**SAN ANTONIO WATER SYSTEM  
DOS RIOS WRC RE-RATING  
HEADWORKS IMPROVEMENTS AND  
PROCESS ENHANCEMENTS PHASE I  
SAWS Job No. 08-6502  
SAWS Solicitation No. B-10-057-DD**

**ADDENDUM No. 1  
November 24, 2010**

Texas Registration Number F-3043	DATE <u>11-23-10</u>	SAN ANTONIO WATER SYSTEM DOS RIOS WRC RE-RATING HEADWORKS IMPROVEMENTS AND PROCESS ENHANCEMENTS PHASE I		ADDENDUM No  1	EXHIBIT No  MD-1-A
		REF SHEET No	LOCATION		
		MD-1

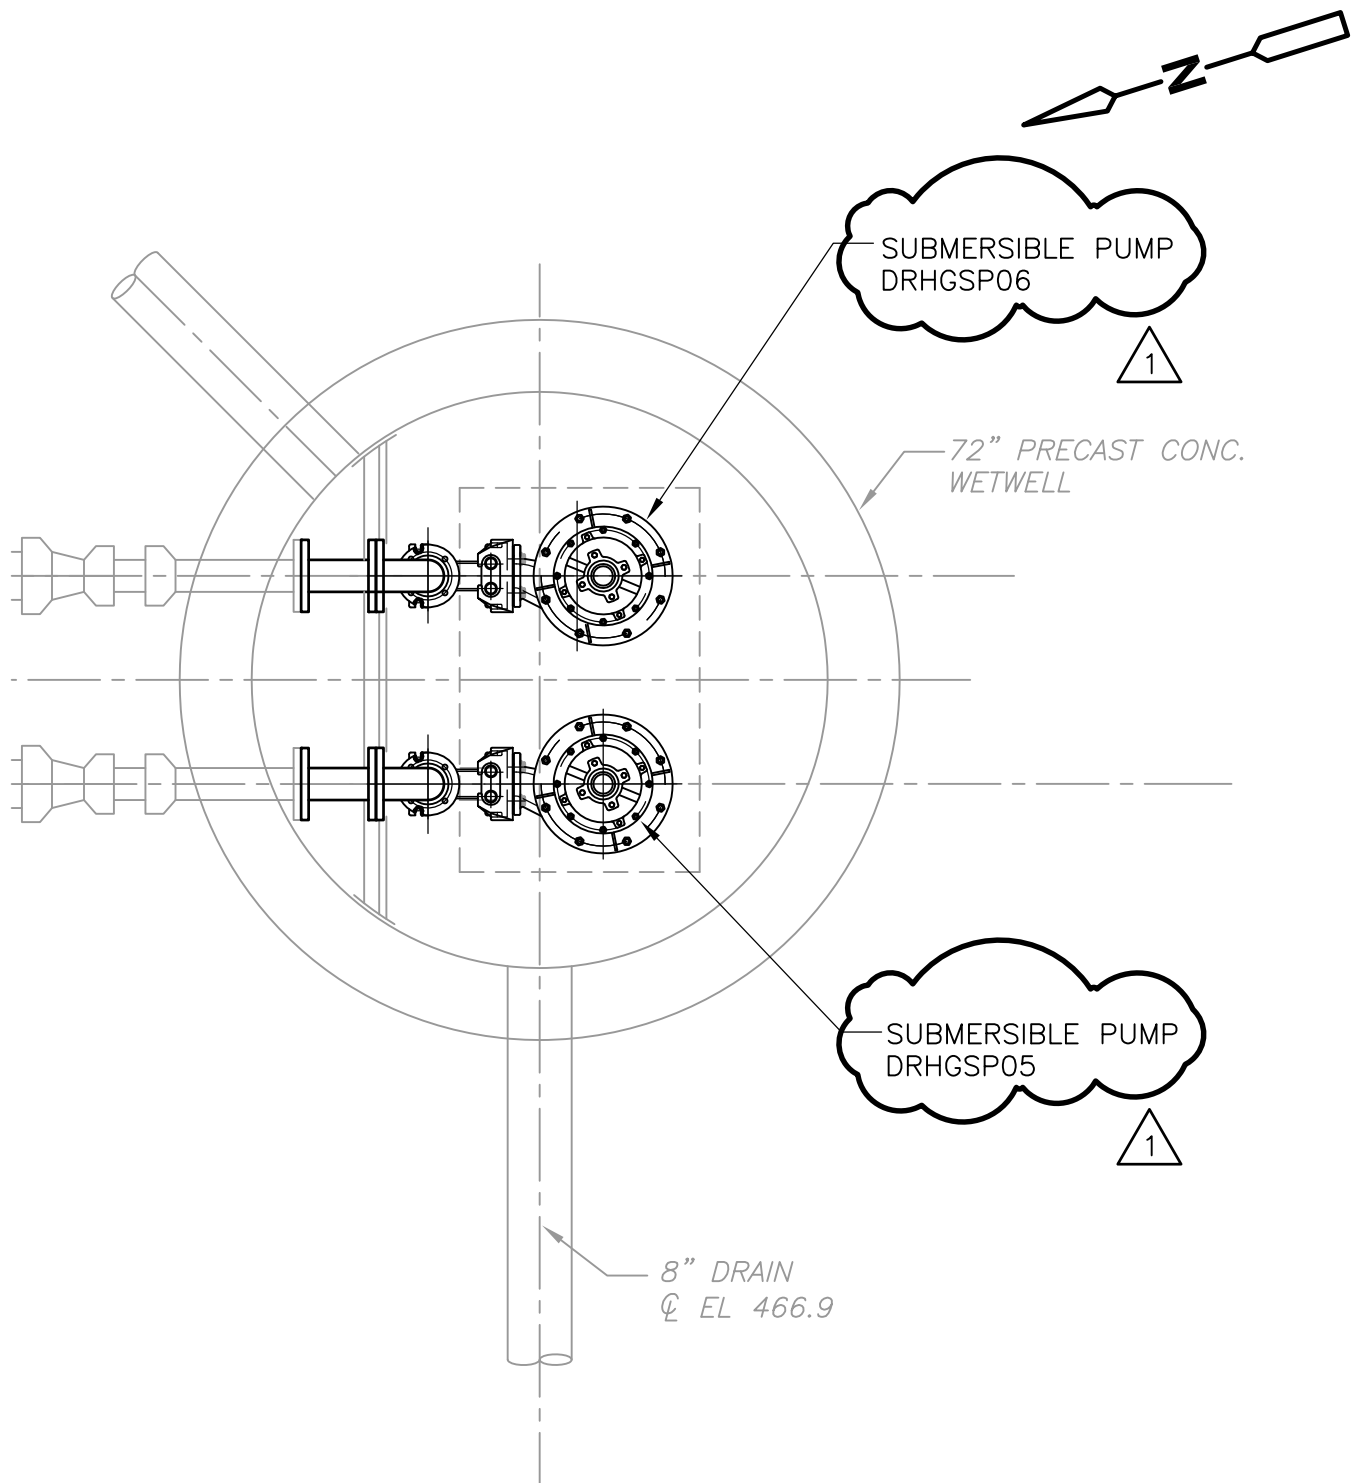
- a) Revise sheet as shown in Exhibit MD1-A.
